SITE EVALUATION REPORT FORM

Name: <u>Randolph Haikio</u>		CASE # <u>06-351</u>	
Applicant Mailing Address: <u>1260 Mead Road</u>		Subject Property Location	
City/State/Zip Code: <u>Rochester Hills, MI 48306</u>		County: <u>Keweenaw</u> Township: <u>Allouez</u>	
Home Phone: (248) 656-8745 Work Phone: cell (248) 613-7768		Section #: <u>31</u> Township #: <u>58N</u> Range #: <u>32W</u> Additional Property Information: <u>10 acres</u> Property Tax ID # <u>42-101-61-000-015</u> , Lot #15	
		Nearest Road (Distance/Direction): <u>7 Mile Point Road</u>

SITE EVALUATION REPORT FORM - SITE DIAGRAM

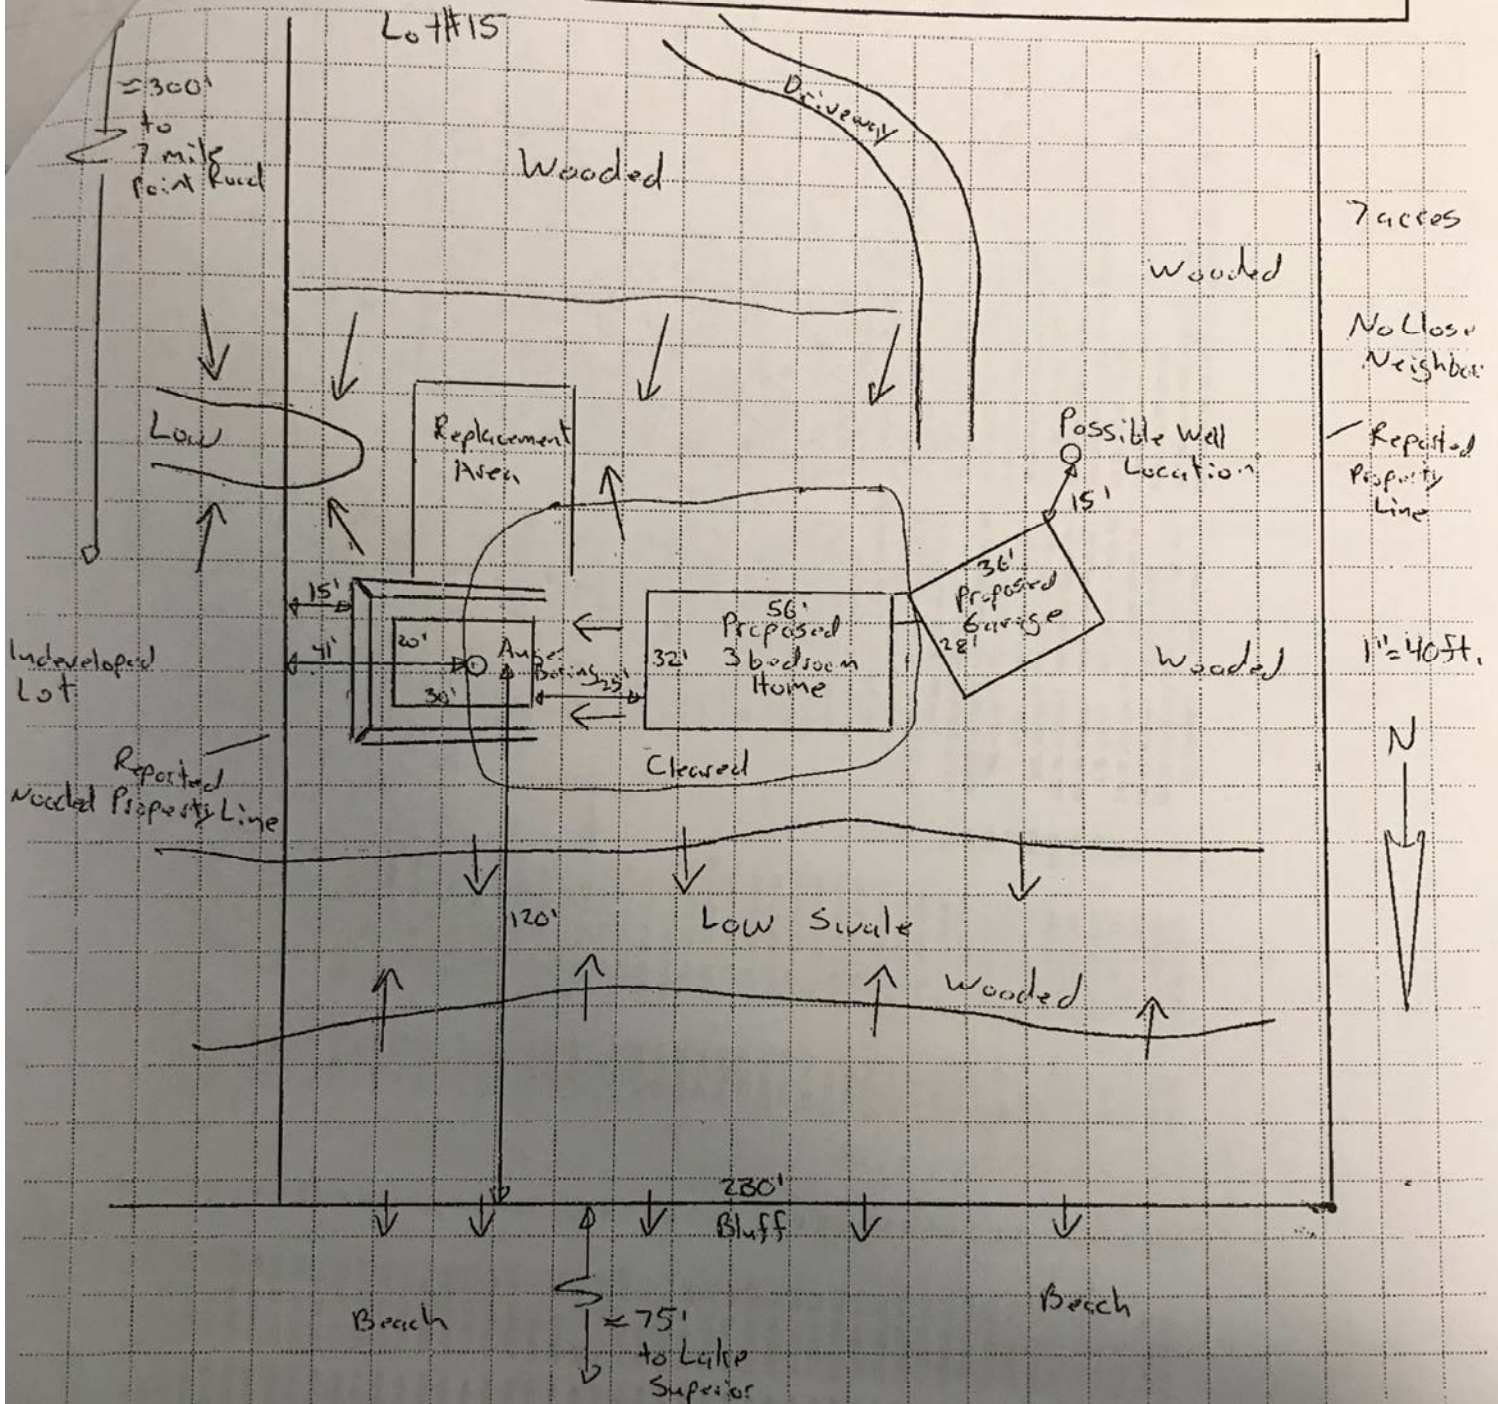
<input checked="" type="checkbox"/> New Construction	Intended Use: Residential/Number of Bedrooms <u>3</u>
<input type="checkbox"/> Replacement/Repair	Public or Commercial System _____
<input type="checkbox"/> Proposed Site Suitable	<input checked="" type="checkbox"/> Proposed Site Suitable With Special Restrictions
<input type="checkbox"/> Proposed Site Unsuitable	<input type="checkbox"/> Further Information Required (Refer to Comments)
Absorption Bed Area (aggregate area): <u>200</u> Ft ² Per Bedroom <u>600</u> Ft ² Total	
Minimum Fill Sand Requirement: <u>14"</u> above highest original grade	
Additional Design/Site Considerations: Remove trees and vegetation by cutting as close to ground level as possible. Do not smear/compact drainfield area with heavy equipment. Add 14" of clean medium sand fill to the drainfield site. Install aggregate and piping at this new elevation. Provide 5 foot sand extensions and 3:1 slope from extensions. Cover with straw/filter fabric and 4-6" of sand based topsoil. Maintain isolation and construction requirements. Seed and mulch with grass.

Limiting Layer: Seasonal high water table Encountered At: 34"

- ☒ Replacement Area is available and the location is shown on the site diagram.
☐ There is no replacement area available on site.

Permit(s) can be issued once the completed application forms and fees are submitted and approved.
 Provide a detailed sewage system design and site map indicating isolation distances to surface water, on-site wells, neighboring wells, property lines, subsoil drains, foundation walls, etc. Ensure all minimum isolation distance requirements set forth in the "Superior Environmental Health Code" are maintained.
 Application forms and informational materials are attached.
